DRAINAGE PLAN

GRADING & DRAINAGE PLAN
TIERRA ENCANTADA RETAIL CENTER

E18/D41

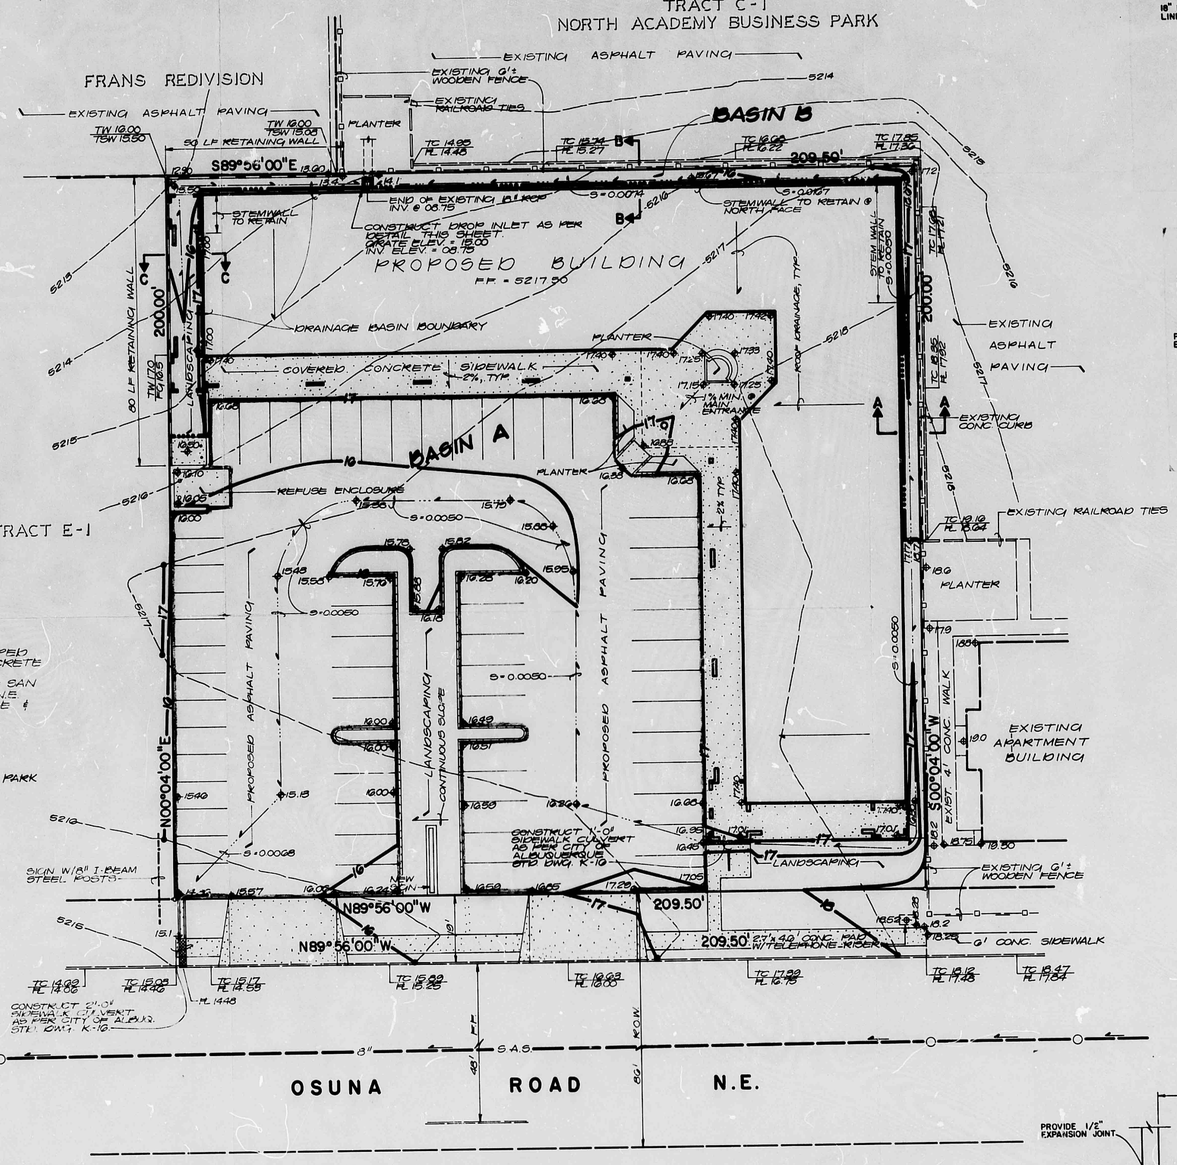
$A_{total} =$ ~~37,900~~ 41,975 sf = ~~0.70~~ 0.96 Ac
$A_{imp} =$ ~~29,600~~ sf; % impervious = ~~87~~ 90 %
Composite CN = 94 (DPM Plate 22.2 C-3)
DRO = 1.5 in (DPM Plate 22.2 C-4)
$q_p = 45.4\ A/T_p =$ ~~3.54~~ 4.36 cfs/in runoff

$Q_{100} = Q_{peak} = q_p$ (DRO) = ~~3.2~~ 6.54 cfs

$V_{100} = 3630$ (DRO) A = ~~7250~~ 5225 cf

$A_{total} =$ ~~18,300~~ 2,225 sf = ~~0.24~~ 0.05 Ac 68
$A_{imp} =$ ~~9,650~~ sf; % impervious = ~~94~~ %
Composite CN = ~~95.96~~ (DPM Plate 22.2 C-3)
DRO = 1.9 in (DPM Plate 22.2 C-4)
$q_p = 45.4\ A/T_p =$ ~~1.09~~ 0.23 cfs/in runoff

$Q_{100} = Q_{peak} = q_p$ (DRO) = ~~2.1~~ 0.43 cfs

$V_{100} = 3630$ (DRO) A = ~~1650~~ 350 cf

$Q_{100} =$ ~~2.3~~ 6.54 + ~~2.1~~ 0.43 - 2.3 = ~~+5.1~~ +4.67
$V_{100} =$ ~~7250~~ 5225 + ~~1650~~ 350 - 1830 = ~~+7070~~ +3745 cf

3) 24" RCP
n = 0.013
A = 3.14 sf
R = 0.50 ft
s = 0.0050
Q = 16.0 cfs (capacity)
Q_{100} basin 4-A = 2.7 cfs (See Tract C)
Q_{100} basin 4-B = 5.3 cfs (See Tract C)
Q_{100} Project site = ~~2.1~~ 0.4 cfs
Q_{100} Total = ~~10.1~~ 8.4 cfs

GRADING & DRAINAGE PLAN
TIERRA ENCANTADA RETAIL CENTER

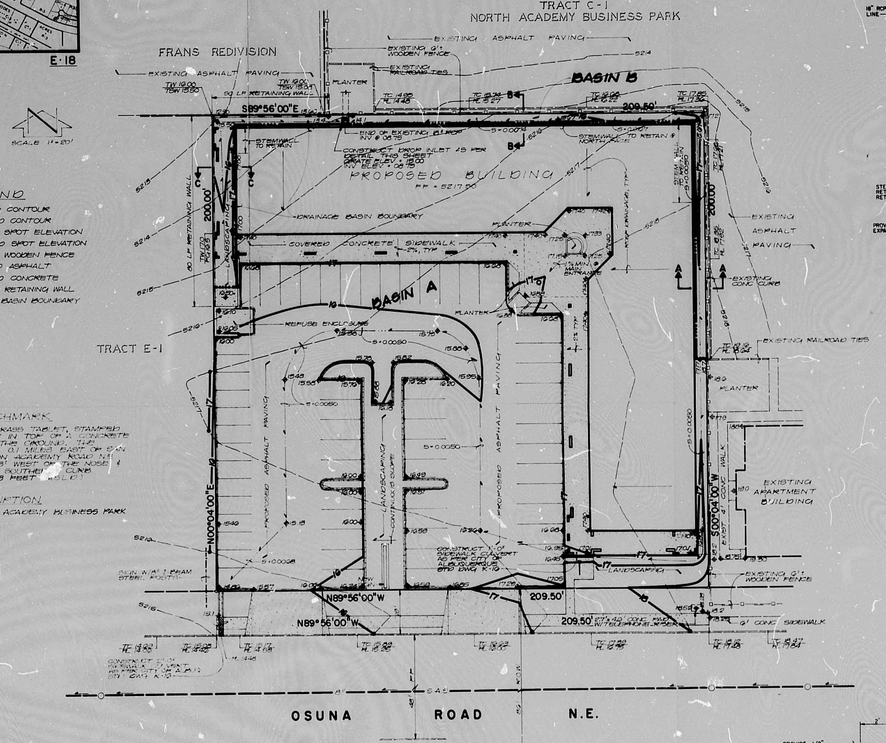
Atotal = 22,900 sf = 0.525 Ac
Aimp = 21,600 sf; % impervious = 94 %
Composite CN = 96 (DPM Plate 22.2 C-3)
DRO = 1.9 in (DPM Plate 22.2 C-4)
Q_p = 45.4 A/Tp = 1.20 / 0.25 cfs/in runoff

$Q_{100} = Q_{peak} = Q_p$ (DRO) = 2.3 cfs

V_{100} = 3630 (DRO) A = 1830 cf

Q_{100} = 6.54 / 2.3 = 2.3 + 4.23 cfs
V_{100} = 5225 / 1830 + 1420 / 350 = 1830 + 1770 cf

Q_{100} Total = 14.3 / 8.4 cfs
